Technical Service Information

THM 4L60-E LACK OF LUBRICATION

Figure 1

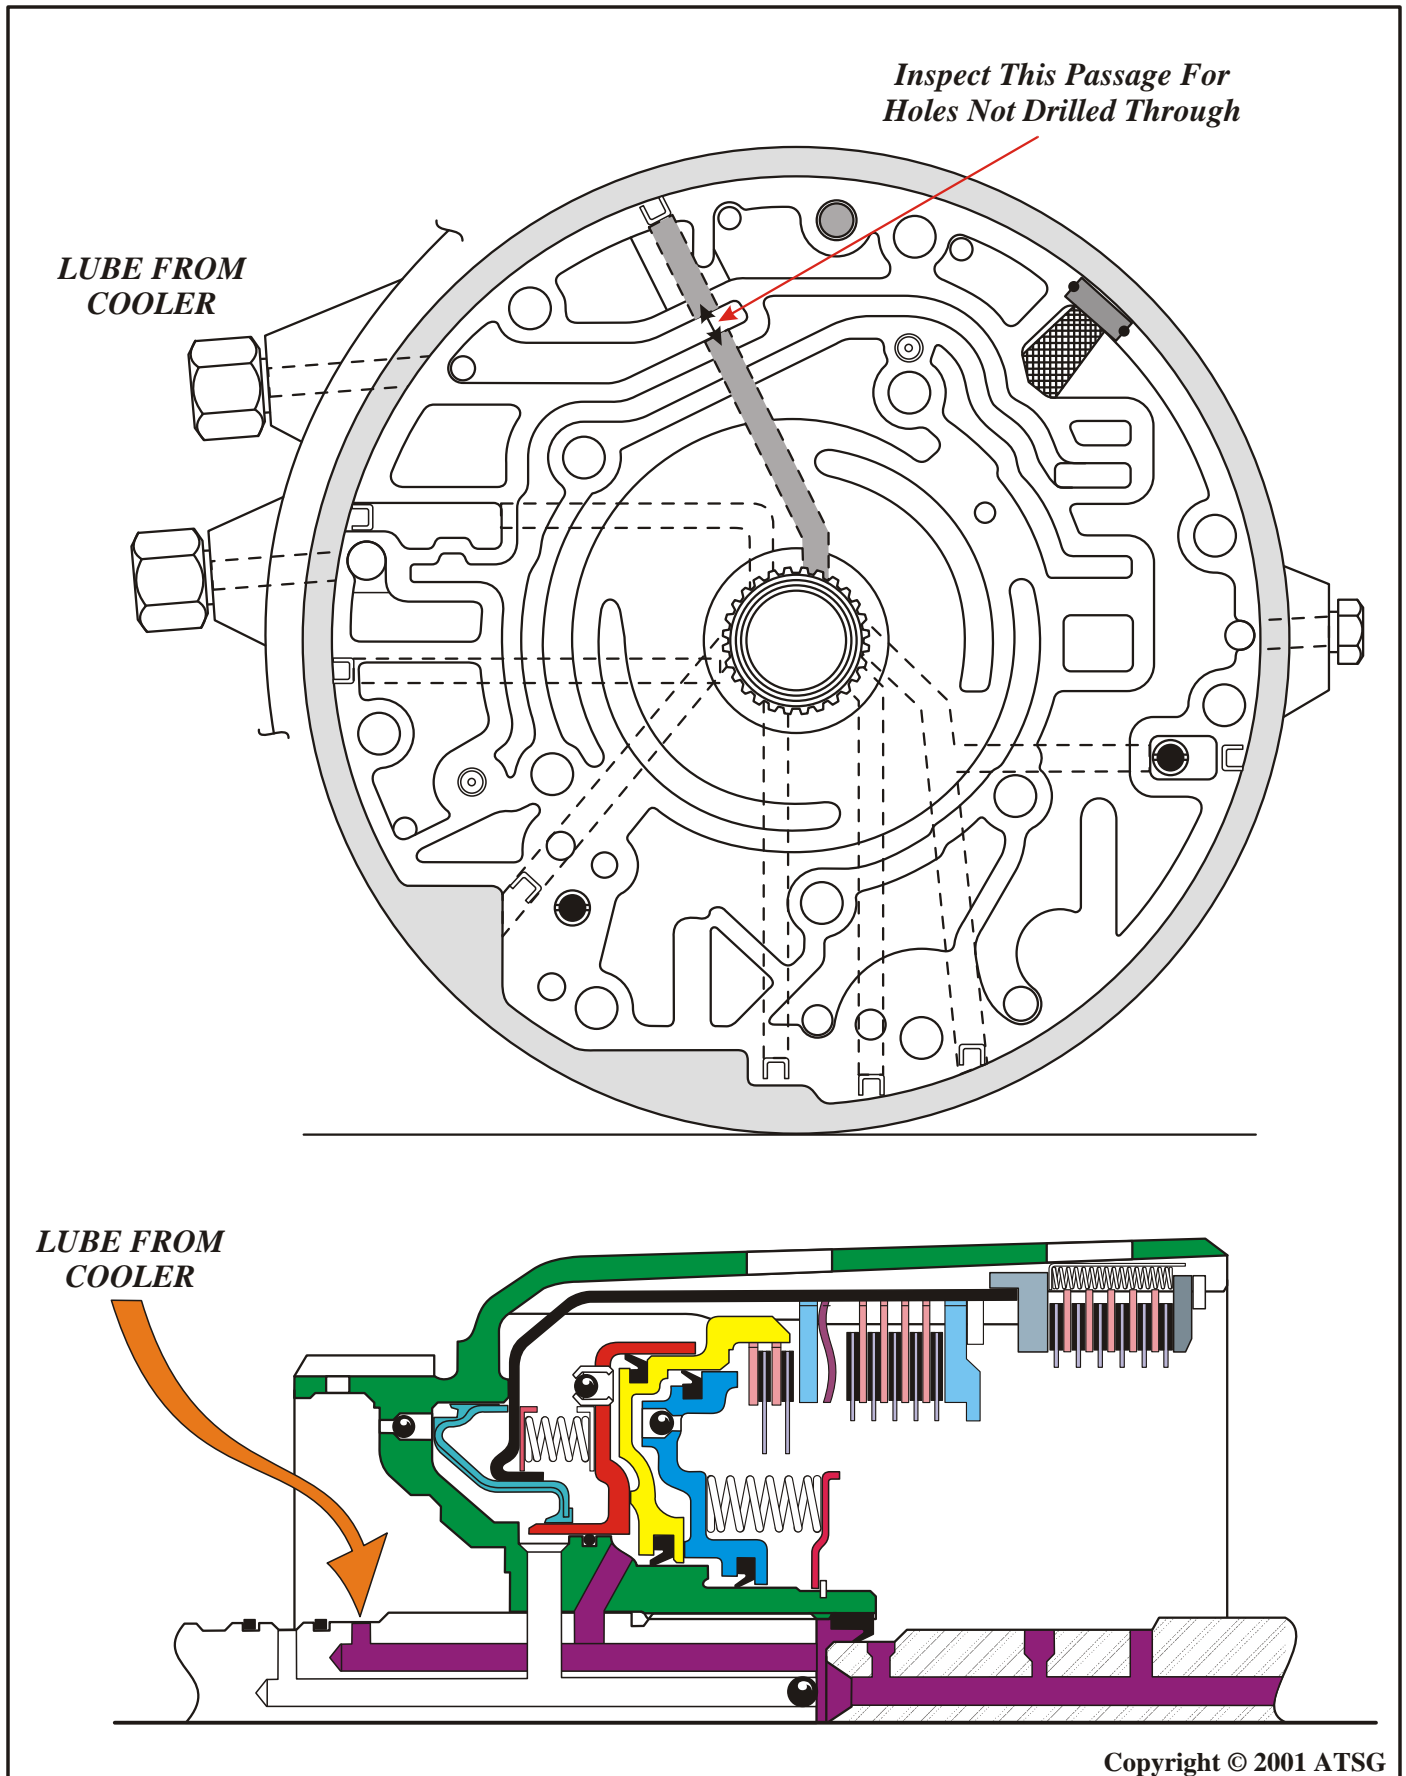
- COMPLAINT:** Vehicle is brought to your shop and has failed because of lack of lubrication. You check the cooler or possibly replace the cooler as a precaution. After replacing the necessary failed parts, the vehicle is returned with the same problem.

- CAUSE:** The cause may be, a defective pump cover (Stator) from the factory, that was not drilled completely through the "Lube From Cooler" passage, as shown in Figure 1. If this passage is not drilled through, there will be no lubrication to the rear of this unit as all lube must pass through the pump cover (See Figure 1). Every one that we have encountered, and we have seen several, had been drilled just deep enough that the cup plug that seals this passage after drilling was installed in the cover.

- CORRECTION:** Replace the pump cover as necessary with a new one and inspect *every* one that enters your shop to ensure no return failures. All of the pump covers we have seen at this point, were the 13 vane variety.
